APPLICATION FOR SUBMITTAL OF POST-APPROVAL DOCUMENT

2. PROJECT INFORMATION:			
School District/Owner: <u>Bakersfield City School District</u>		DSA File Number: <u>15 6</u>	
Project Name/School: <u>Dr. Martin Luther King Jr. Elementary School</u>		DSA Application Number <u>03 122605</u>

ADDENDUM NO. 2
PROJECT MANUAL
MLK ELEMENTARY SCHOOL
WELLNESS CENTER
BAKERSFIELD CITY SCHOOL DISTRICT

Project No.: 5527
DSA File No. 15-6
DSA App No. 03-122605
December 19, 2024

Sheet No.: **M2.11**

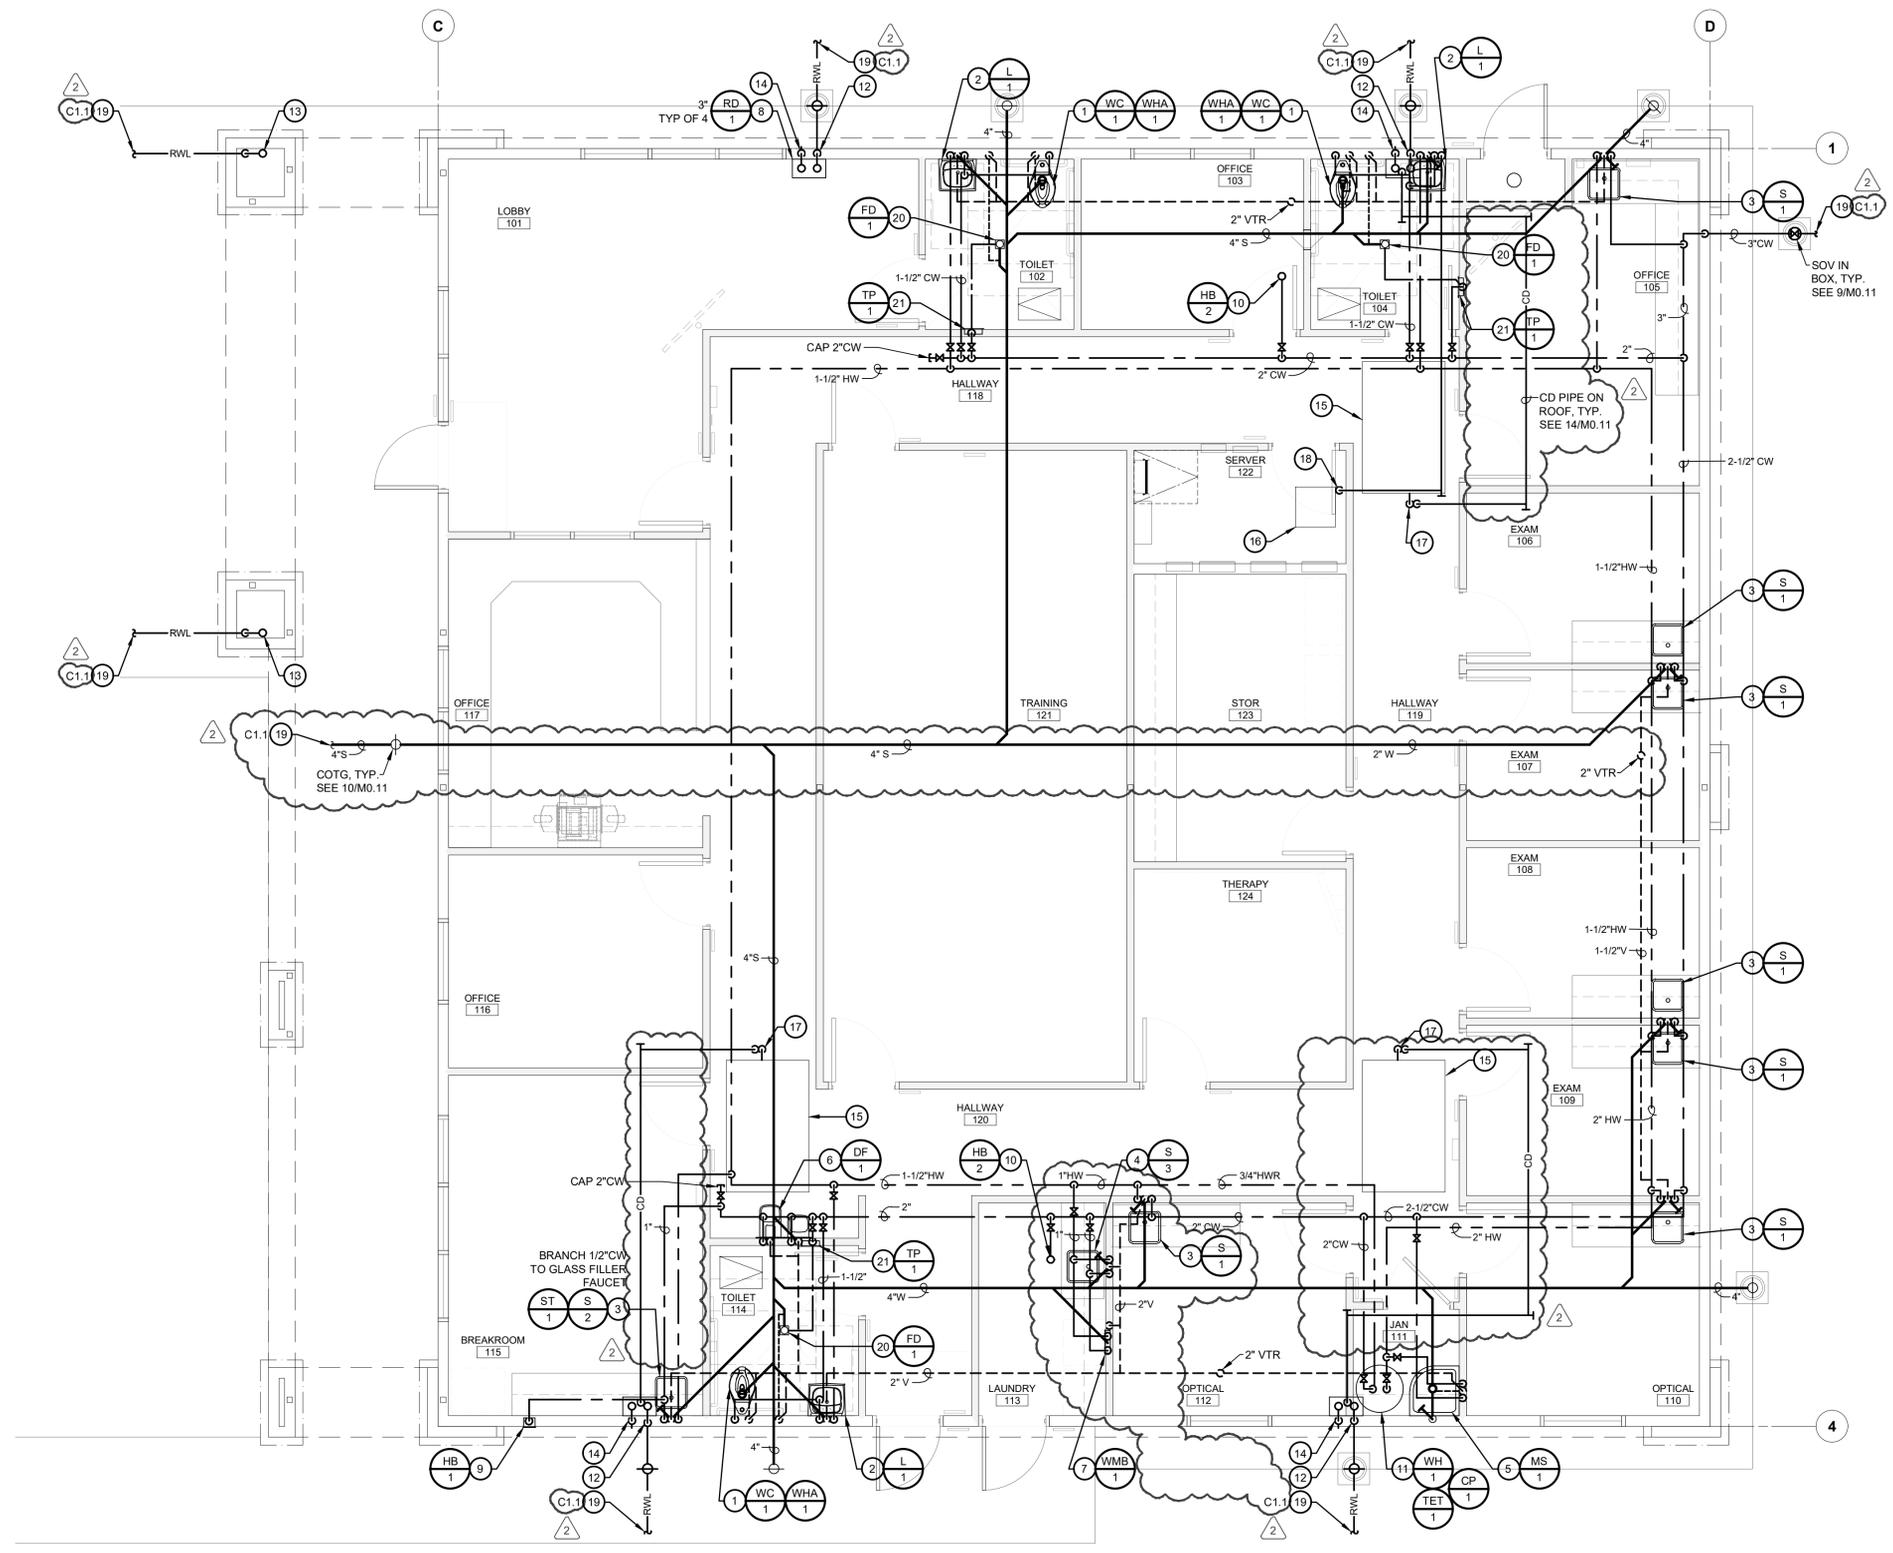
2-29 DRAWING, SHEET M2.11 – HVAC PLAN: Note the following changes (See M2.11 Addendum 2 drawing):

1. Change location of wireless repeater in room 122. See keynote 7.

2. Exhaust fans have been modified. See keynote 2.
3. Keynotes 1, 2, 4, 5, 6 and 7 have been modified.
4. Legend have been added.
